# City of Chowchilla

## Curb Ramps

### Access Compliance Survey Report

DRAFT

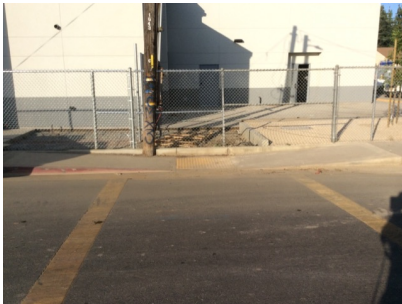
Demolish existing and provide new top landing sloped at 2% max. Curb ramp to remain.

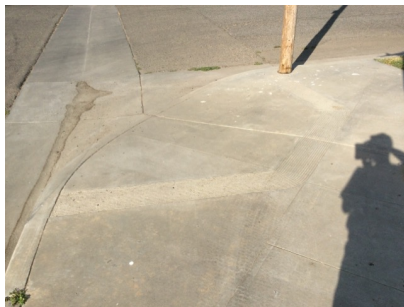
Demolish existing and provide new, parallel curb ramp, including detectable warning surfaces, and top and bottom landings as required.

**W Curb Ramp Required**

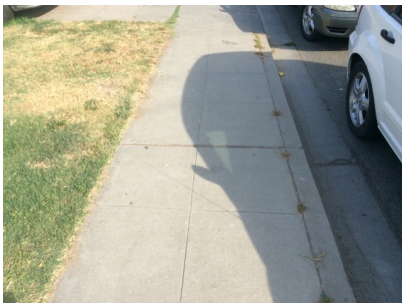
- *As-Built Description:*  
Curb ramp or blended transition not provided where a pedestrian access route crosses a curb.
- *Proposed Solution:*  
Provide a parallel curb ramp, including detectable warning surfaces, and top and bottom landings as required.

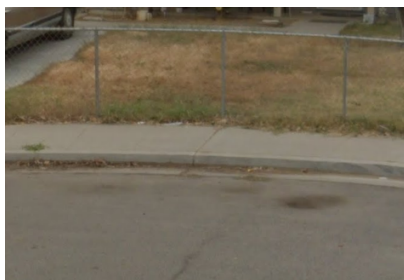
Provide a parallel curb ramp, including detectable warning surfaces, and top and bottom landings as required.
